3.0 DESIGN OF STRUCTURES, COMPONENTS, EQUIPMENT AND SYSTEMS

Figure 1. Comparison of the horizontal PBSRS calculated by the NRC staff, the horizontal PBSRS calculated by the applicant, and the Westinghouse CSDRS. NRC SCOR FIRS Site Response Confirmatory Analysis

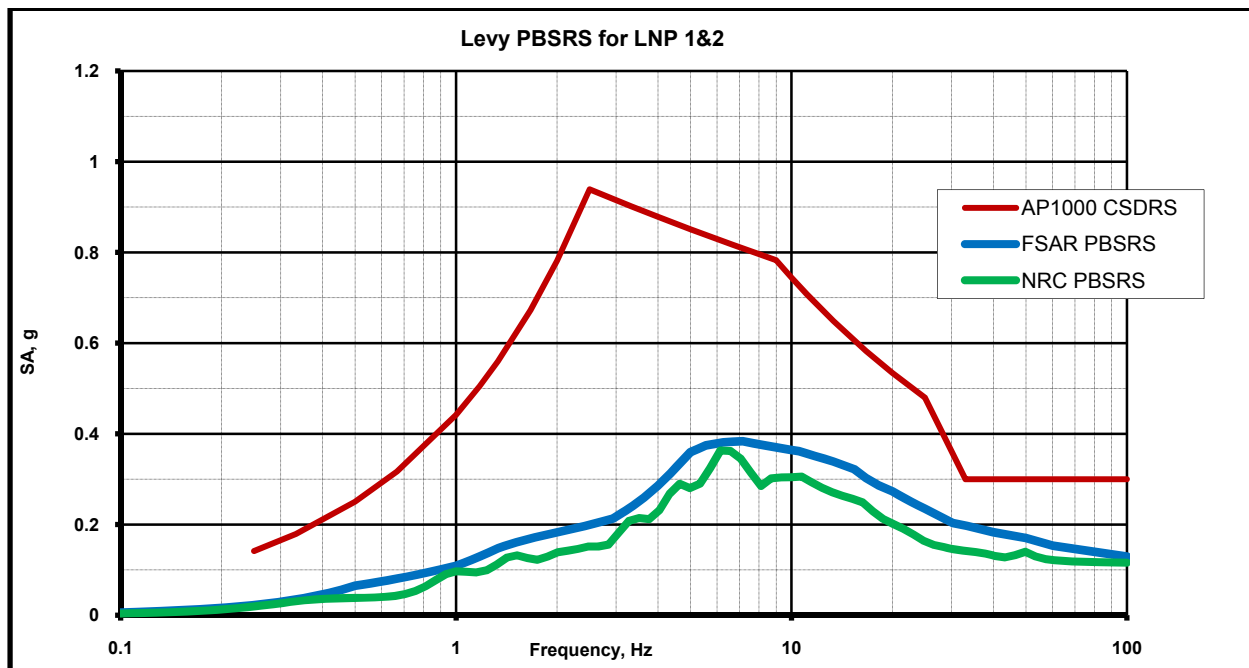
Figure 1 shows the comparison of the staff's calculated PBSRS with the PBSRS calculated by the applicant (FSAR Table 2.5.2-227 and FSAR Figure 2.5.2-297) together with the AP1000 CSDRS. The staff's PBSRS is enveloped by the applicant's and by the CSRDS. Therefore, the staff concludes that in the frequency range significant to a reactor's structures, systems, and components, there are no significant differences between the staff's and the applicant's calculated amplification functions and the PBSRS for the 10^{-4} and 10^{-5} hazard levels.

Figure 2. Comparison of the horizontal FIRS at the elevations of -7 m (-24 ft) and +3.3 m (+11 ft) calculated by the NRC staff, the horizontal FIRS at the same elevations calculated by the applicant, and the Westinghouse CSDRS.

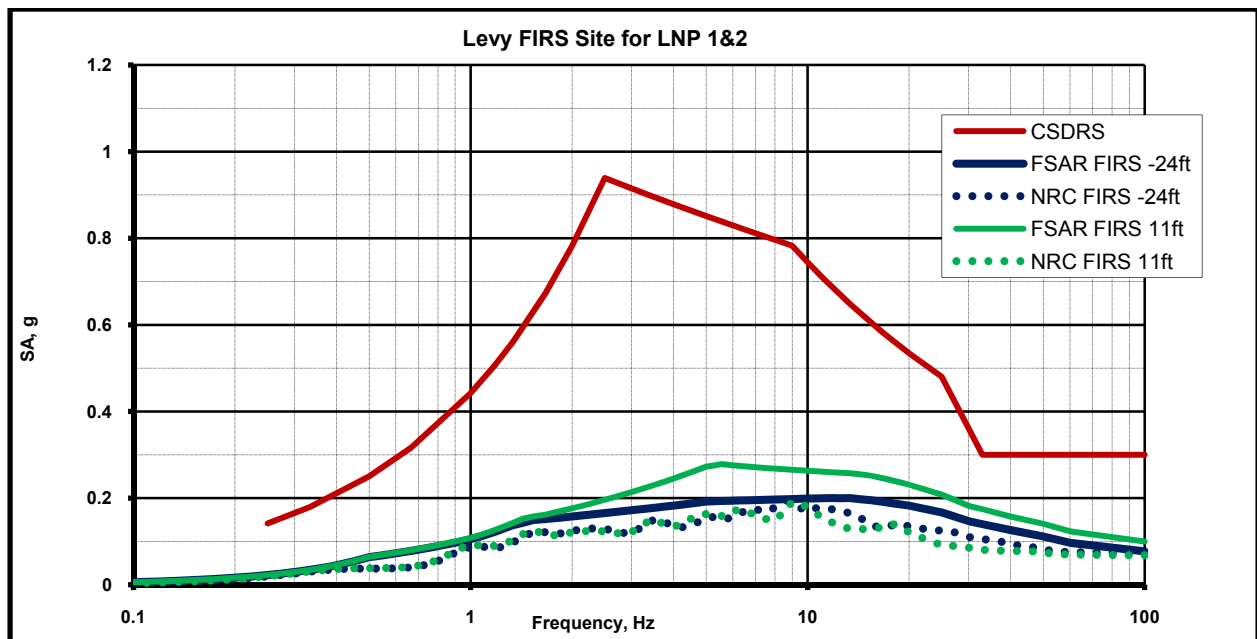
The staff's calculation of the FIRS at both elevations of -7 m (-24 ft) and +3.3 m (+11 ft) are enveloped by the applicant's FIRS and by the CSRDS. Therefore, the staff concludes that in the frequency range significant to a reactor's structures, systems, and components, there are no significant differences between the staff's and the applicant's calculated amplification functions and FIRS for the 10^{-4} and 10^{-5} hazard levels.
